SUBJECT: Empennage Trim Fitting And Mounting Hardware Replacement Instructions - from Mooney Aviation Company's Service Bulletin M20-313.

MODELS/ SN AFFECTED: ALL Mooney M20B - M20C - M20D , M20E - M20F - M20G - M20J - M20K M20L, M20M, M20R, M20S, M20TN

TIME OF COMPLIANCE: **MANDATORY BEFORE NEXT FLIGHT -**

Figure SB M20-314-1 - EMPENNAGE TRIM FITTING AND MOUNTING HARDWARE

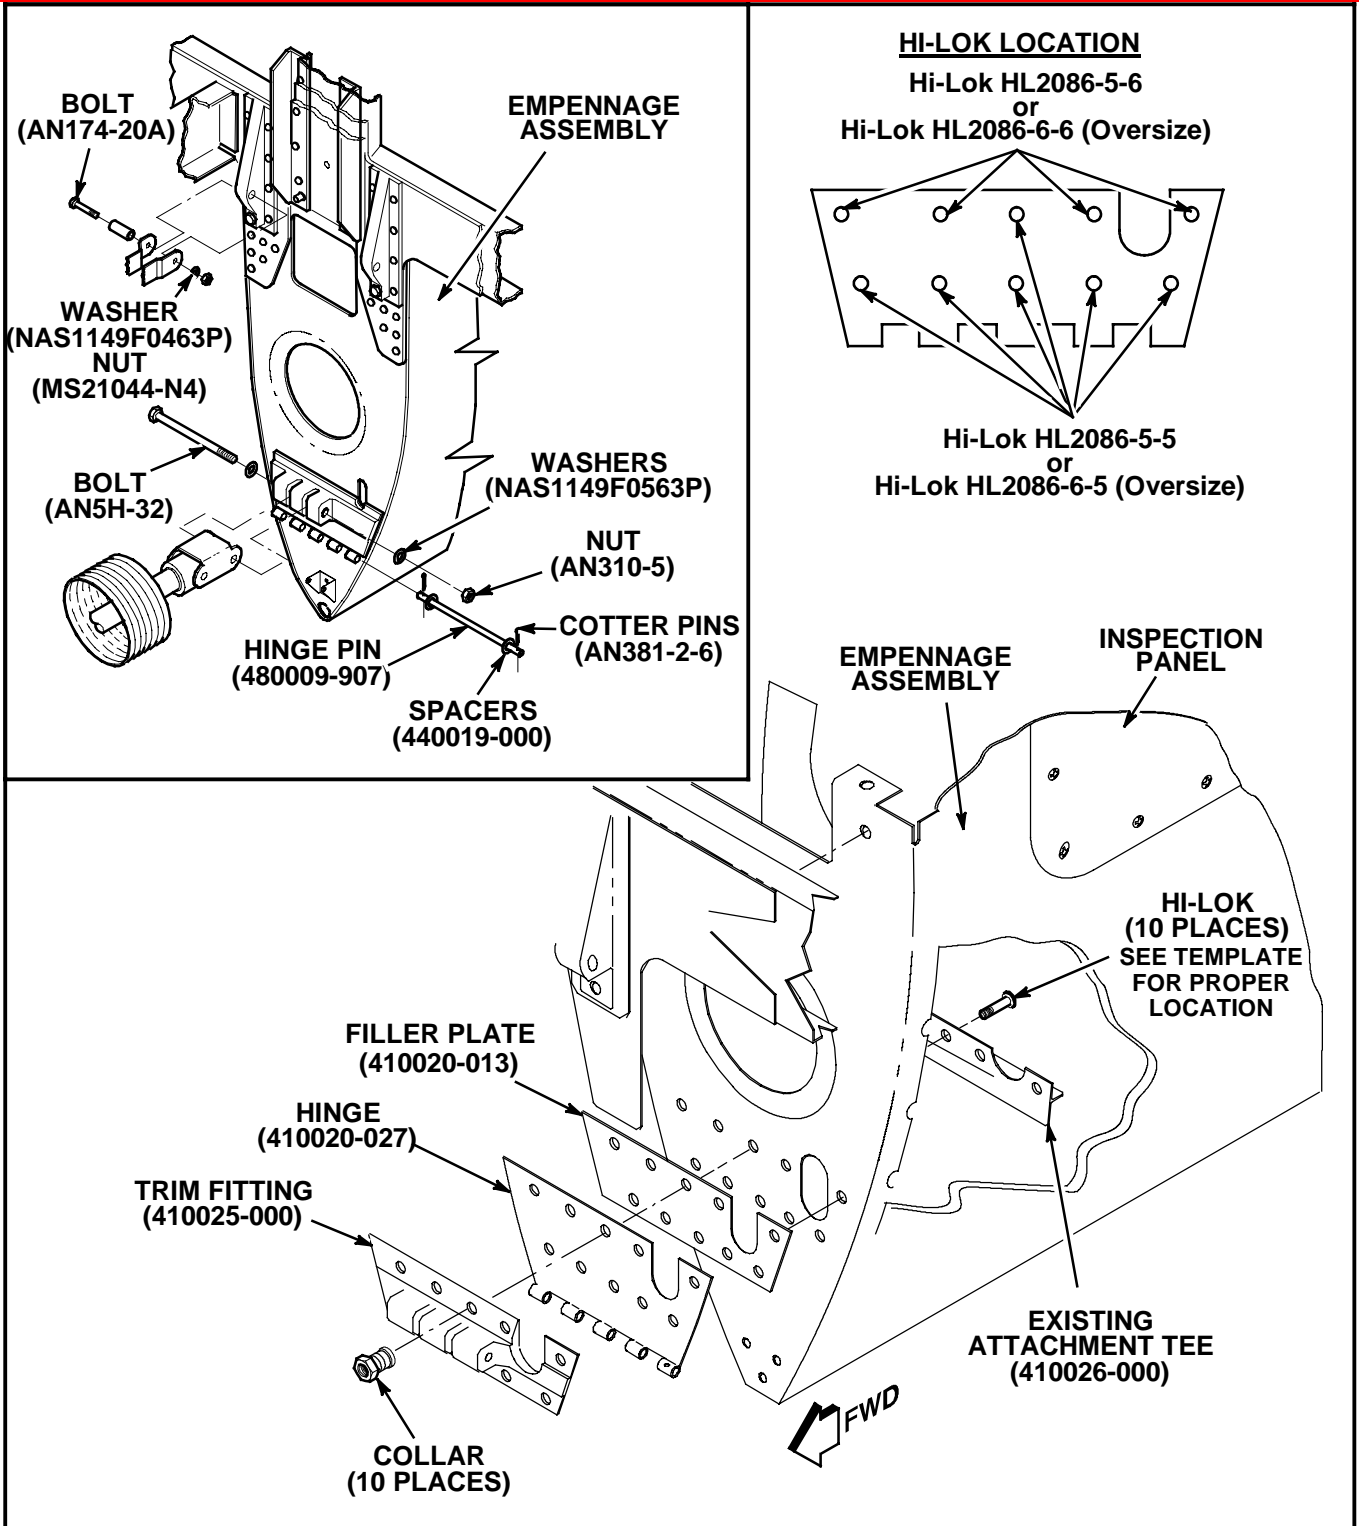
- 1.8. Using the new parts from the M20-314-001 kit, stack components: Trim Fitting (p/n 410025-000) Hinge (p/n 410020-027) and Filler Plate (p/n 410020-013) then match drill all components to existing structure, refer to Figure M20-314-1.

- 1.10. Secure new parts with new (4 qty) Hi-Lok (p/n HL2086-5-6) and (6 qty) Hi-Lok (p/n HL2086-5-5) fasteners into place as required. The orientation of hardware is reversed for ease of installation, refer to Figure M20-314-1.
